Environmental Implementation Report / Functional Servicing Study for 14 Mile Creek West and the Lazy Pat Farm Property

407 West Employment Lands, 3269 Dundas Street (Lazy Pat) Oakville

North Oakville Agency Review Meeting – EIR/FSS

Figure 7: Water Temperature at Maximum Pond Depth: 2-3 m Depth
14W-14A

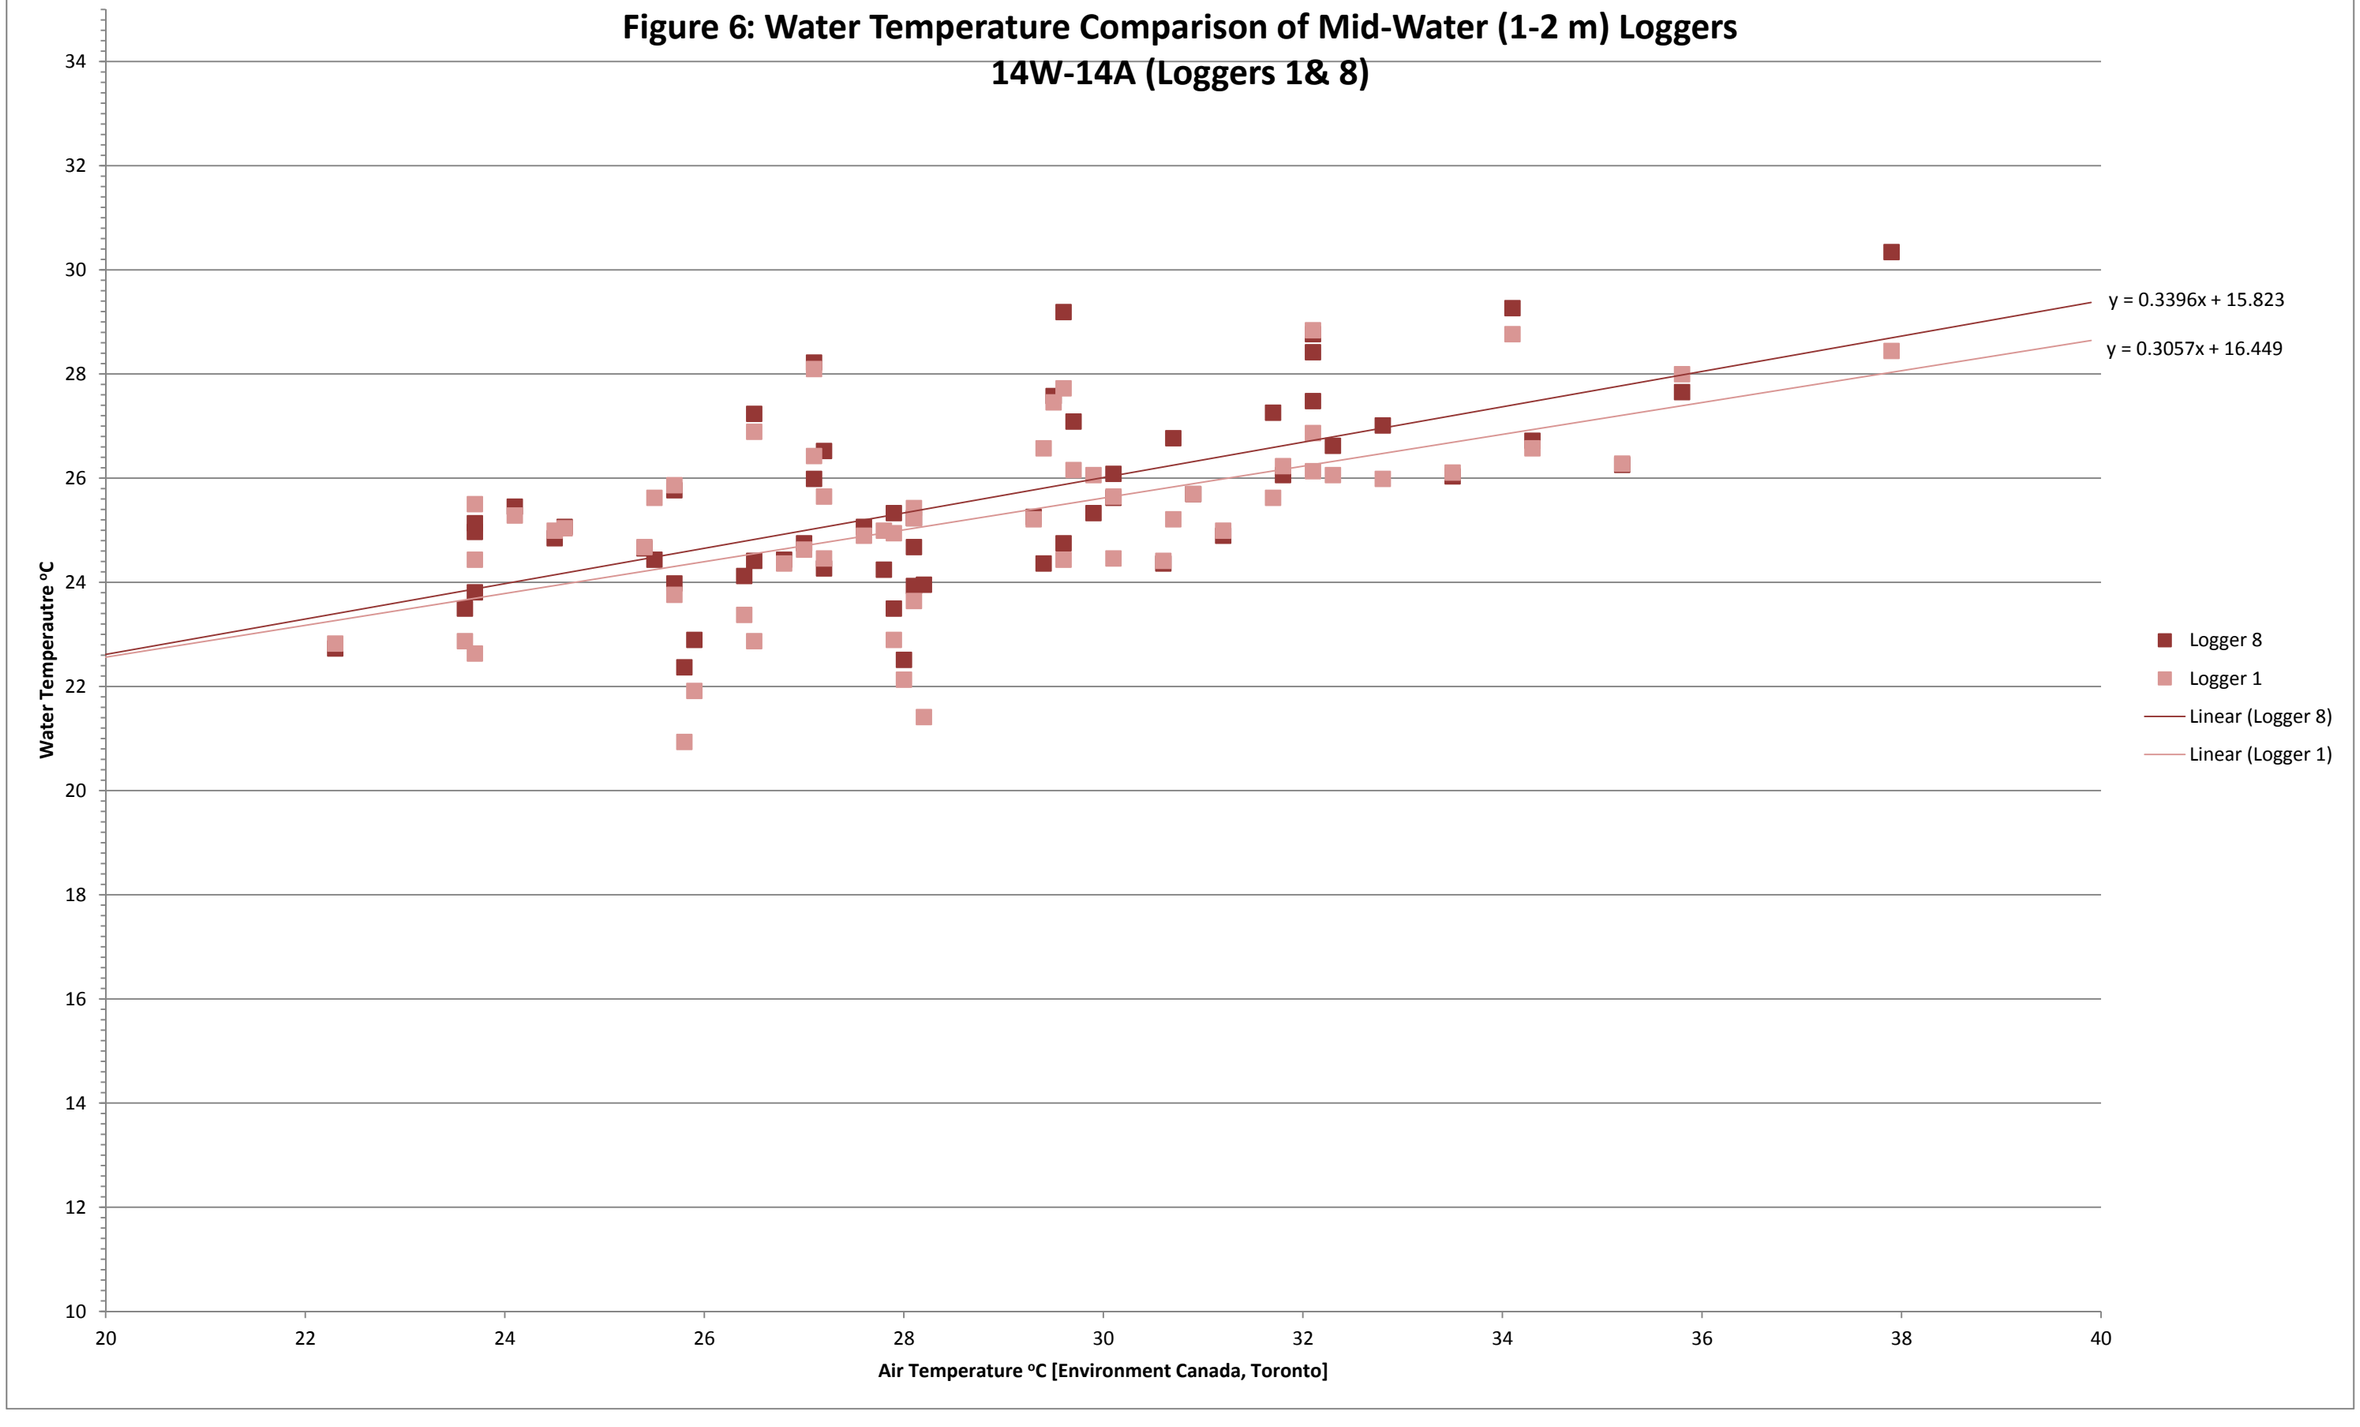
79. **Figures 4 -7, Water Temperature Comparisons at a variety of Water Depths**: Staff appreciates the effort in presenting the data in this graphical format. Staff also request that the raw numerical data be submitted to CH. Figure 7 "Water Temperature at Maximum Pond Depth: 2-3 m Depth" indicates a negative correlation between water temperature (at the deepest portion of the pond) and air temperature. It is noted that water temperature is generally observed to decrease as air temperatures increased. It is noted that on a day when air temperatures were recorded to reach 38 degrees Celsius, the water at the bottom of the pond remained at less than 21 degrees Celsius, which is cold enough to sustain Brook Trout.

79. **Figures 4 – 7 Water Temperature Comparisons at a Variety of Water Depths**: Comment no longer relevant.

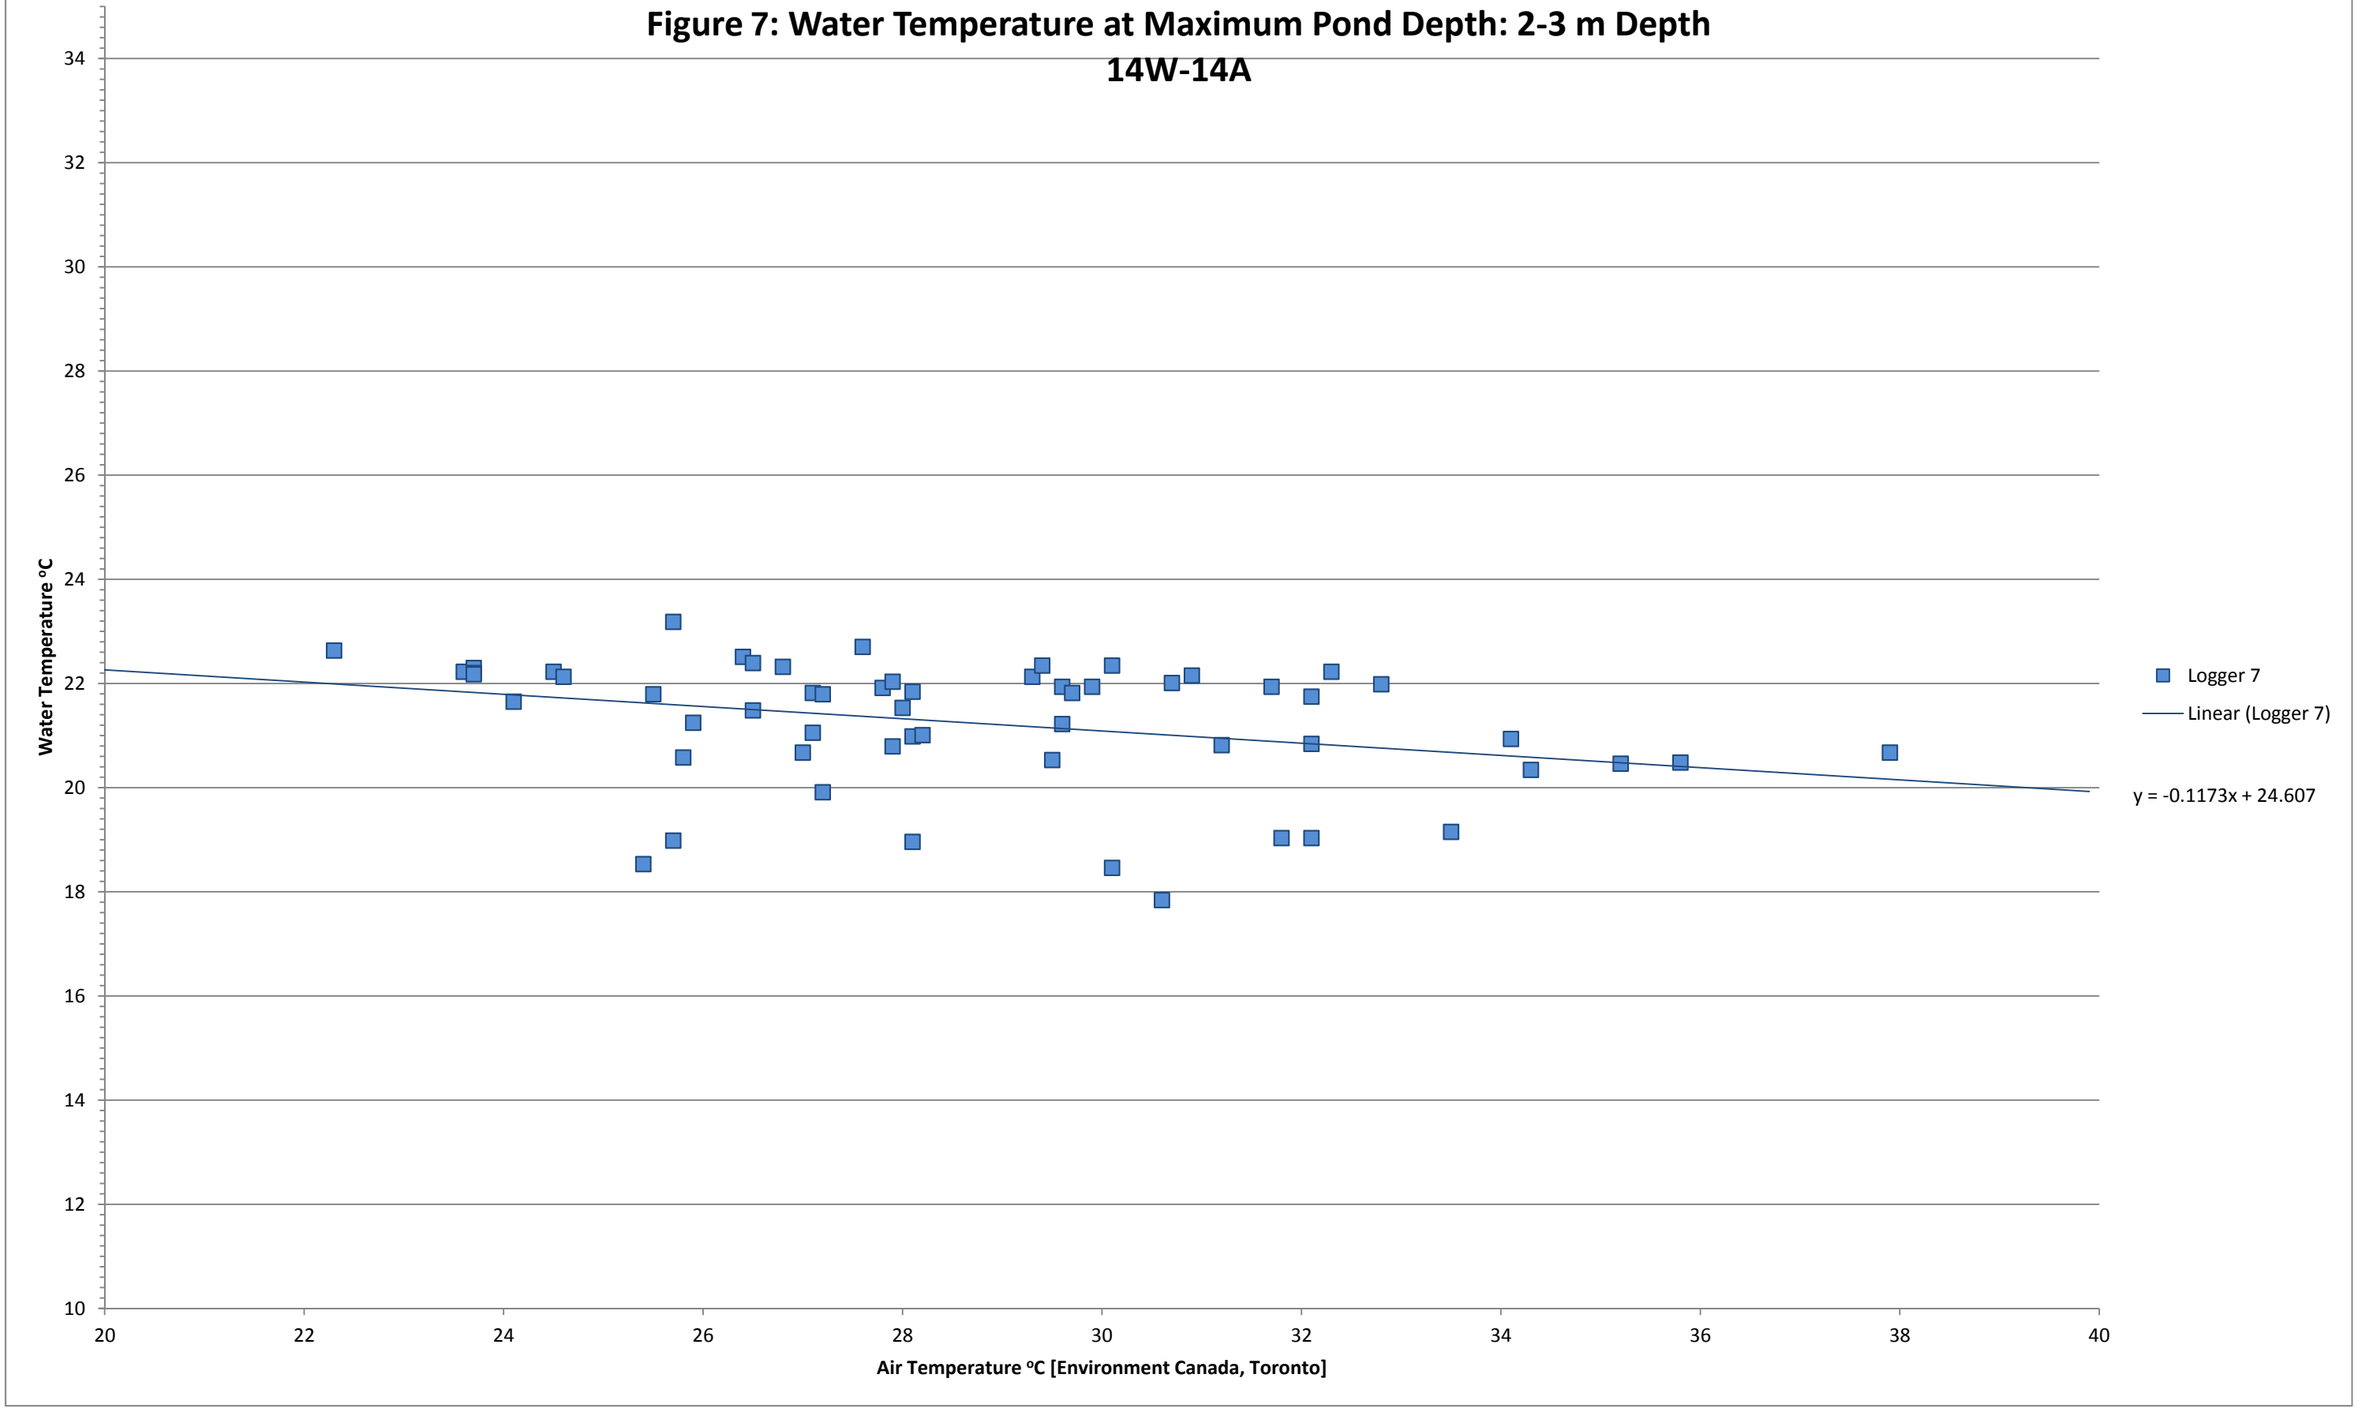
29. **Section 5.3.7 Hydrogeology:** Based on the data submitted in the Technical Memorandum NH number 1 – Reach 14W-14A Aquatic Habitat (e.g. Figure 7 Water Temperature at Maximum Pond Depth: 2-3m Depth 14W-14A), and the data submitted in the Technical Memorandum HG number 1 – Hydrogeology (Figures SWL-16 to SWL-18), it would appear to indicate that groundwater is influencing 14W -14A in the deepest section of the pond. Notwithstanding the above, staff does not object to the relocation of Reach 14W-14A. Staff appreciate the effort, time and cost the proponents contributed to the collection of this data.
